#### CHARTER TOWNSHIP OF VAN BUREN PLANNING COMMISSION AGENDA Wednesday, October 13, 2021 – 7:30 PM REMOTE MEETING –AGENDA

# ITEM # 1 Case 21-021- General Development Company, LLC - Special Land Use request

#### ITEM # 2 Case 21-021- General Development Company, LLC – Preliminary Site Plan

TO:Van Buren Township Planning CommissionFROM:Dan Power- Director of Planning and Economic DevelopmentRE:Case 21-021: General Development Company, LLC - Special<br/>Land Use and Preliminary Site Plan RequestDATE:October 6, 2021

SHEET Soil Erosion Control Plan

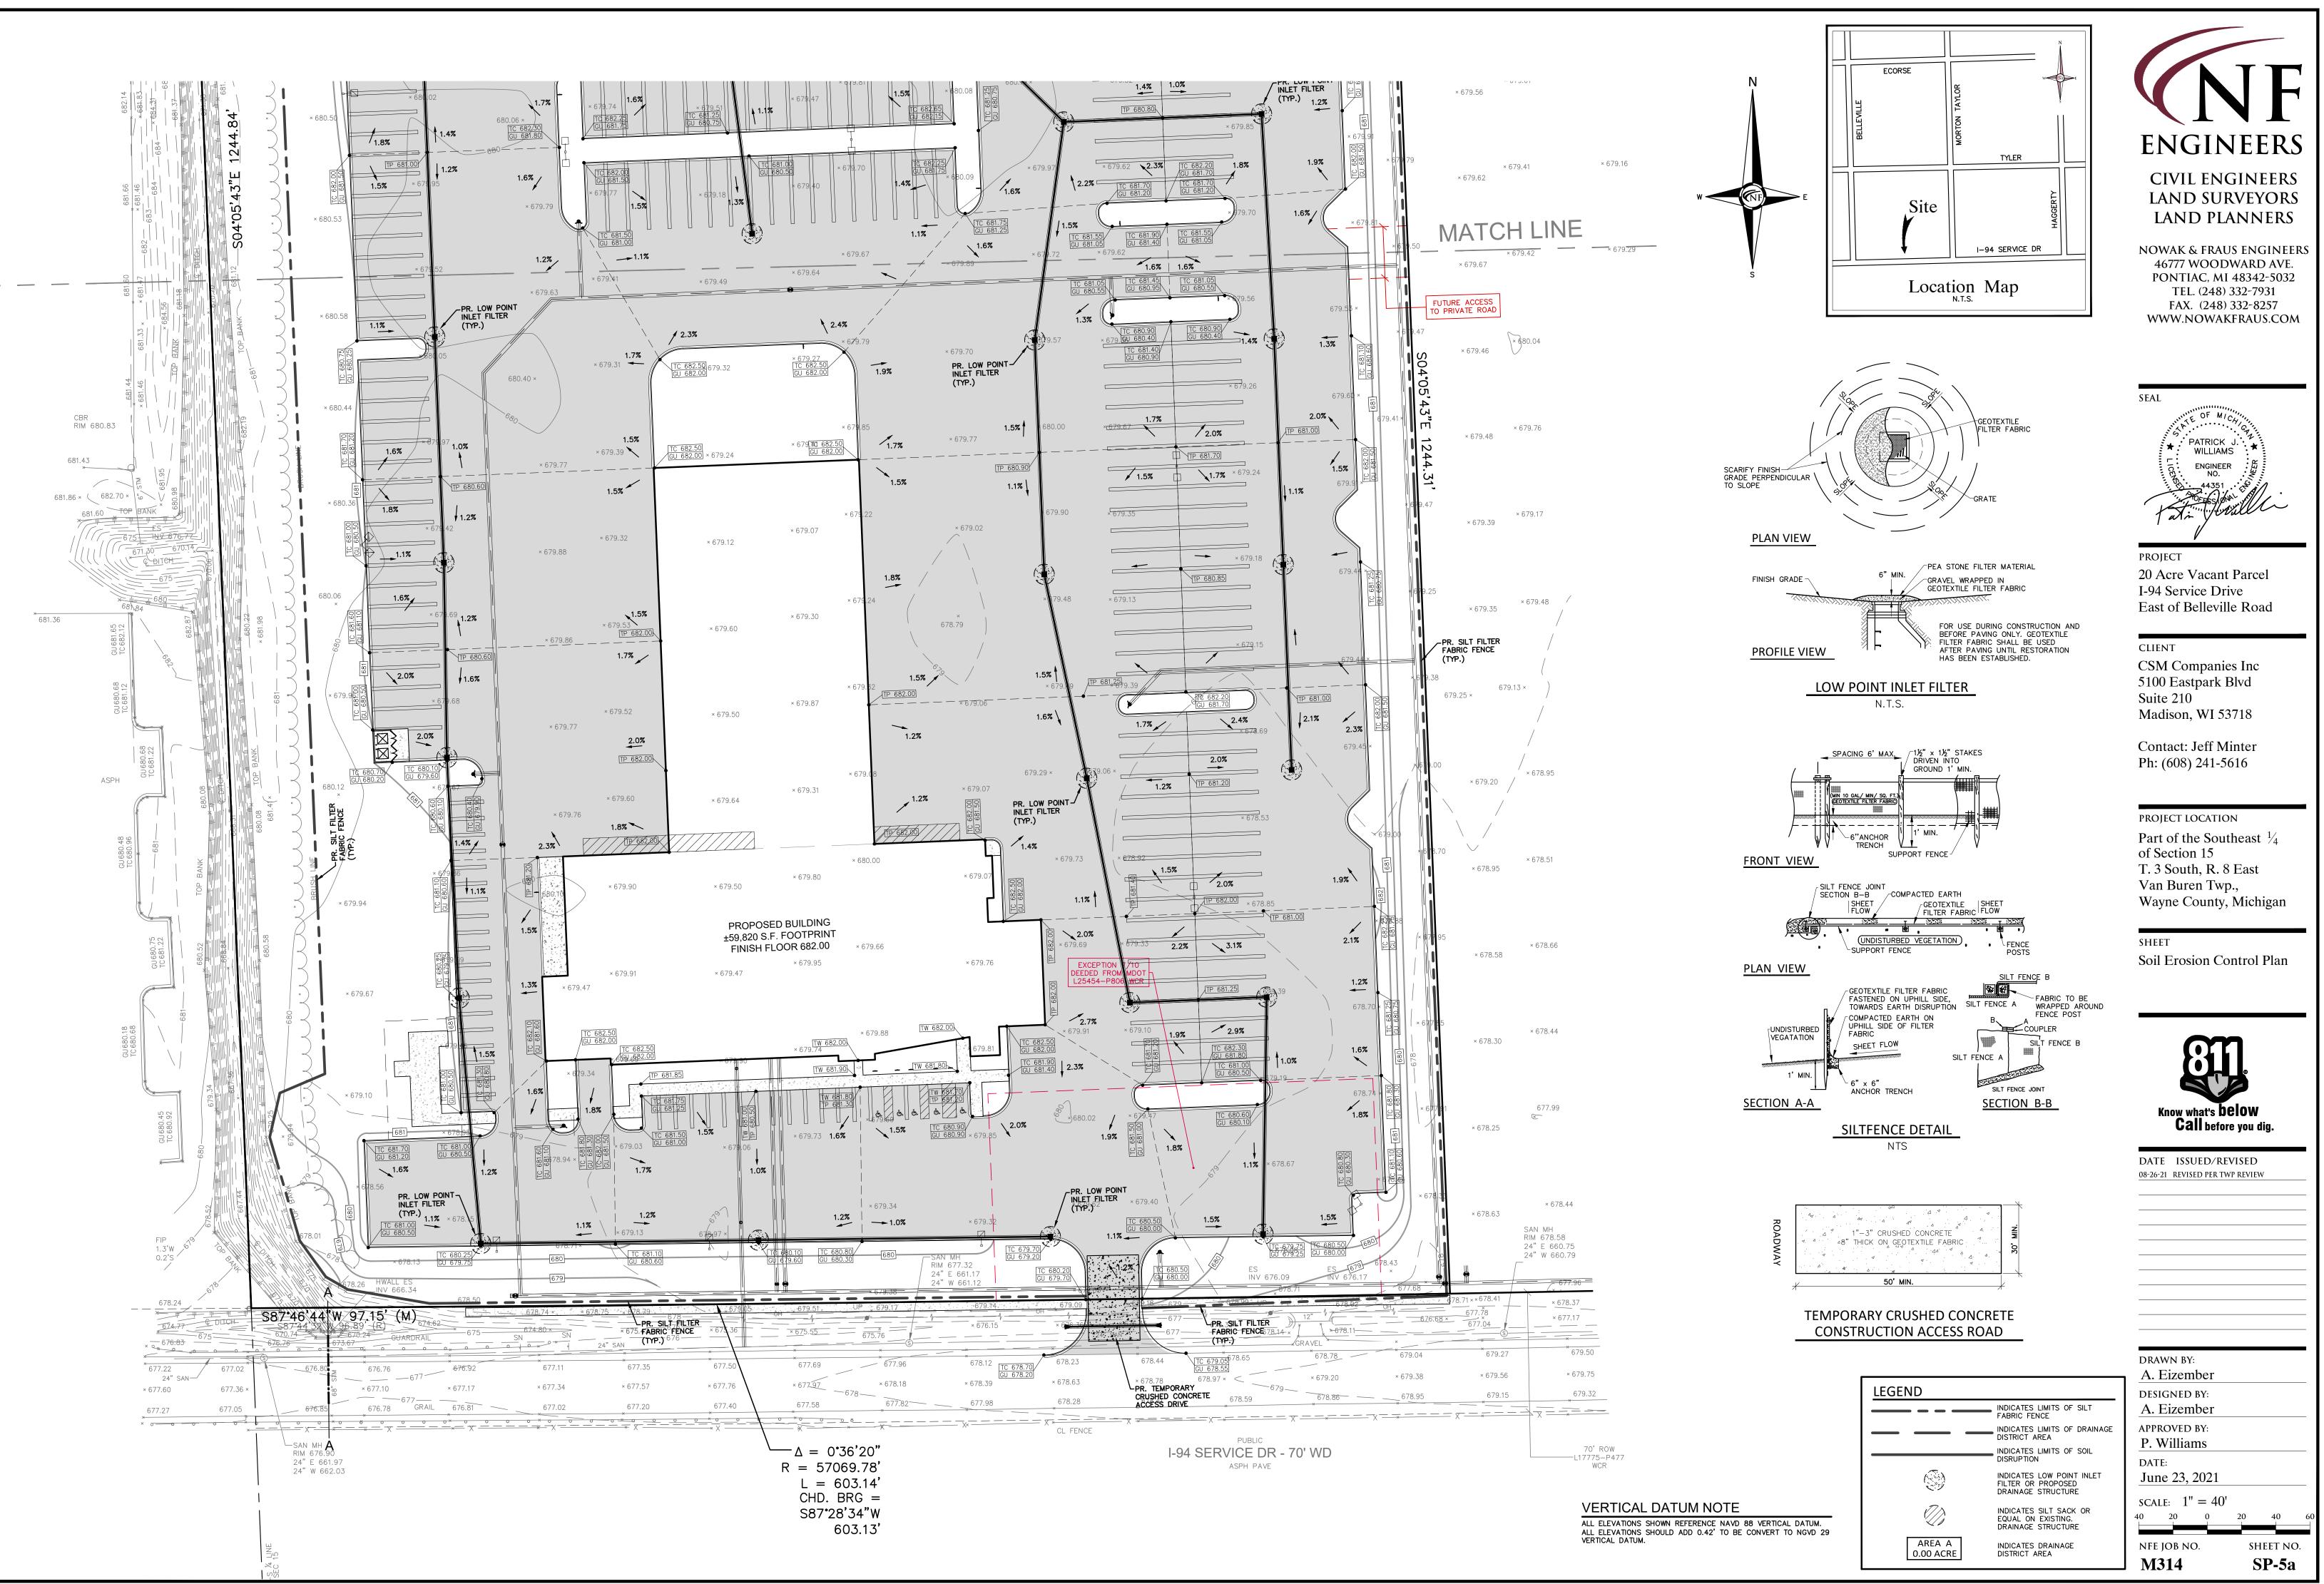
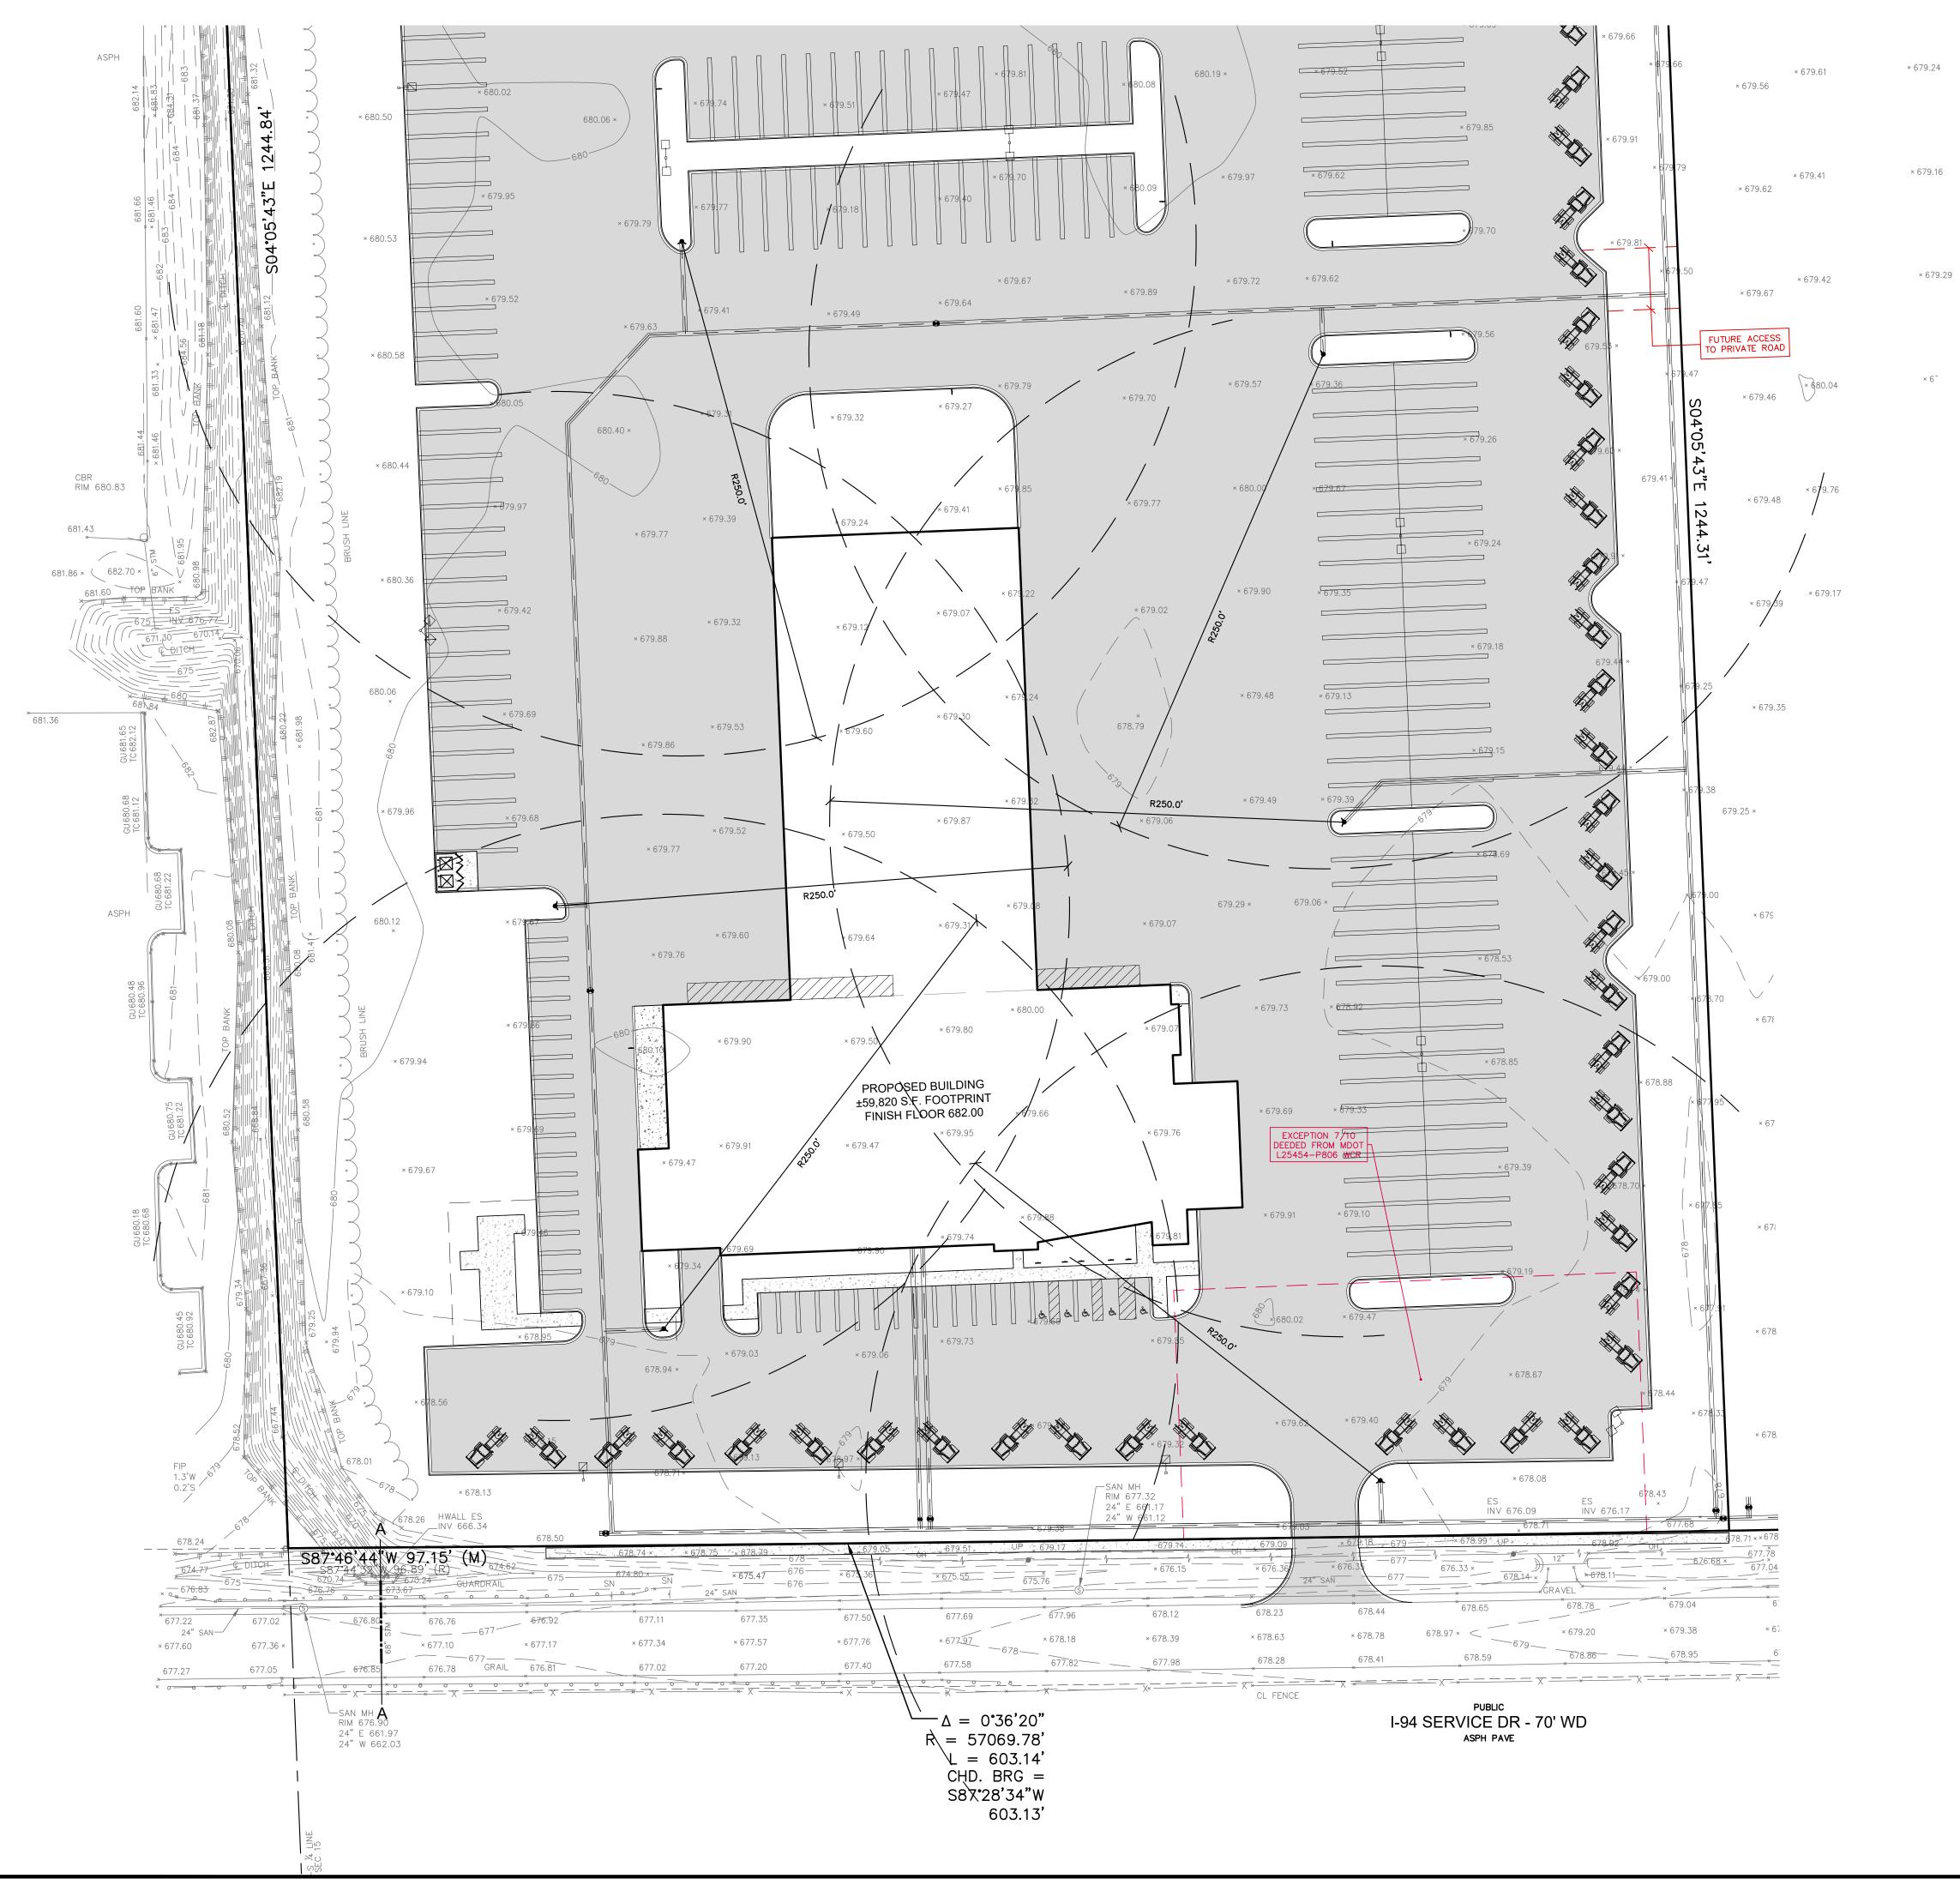
The distance from the hydrants on the North West and North East corners is over 500 feet to the northern most parking area. A fire hydrant needs to be added in the north parking lot. (Sheet SP-5)
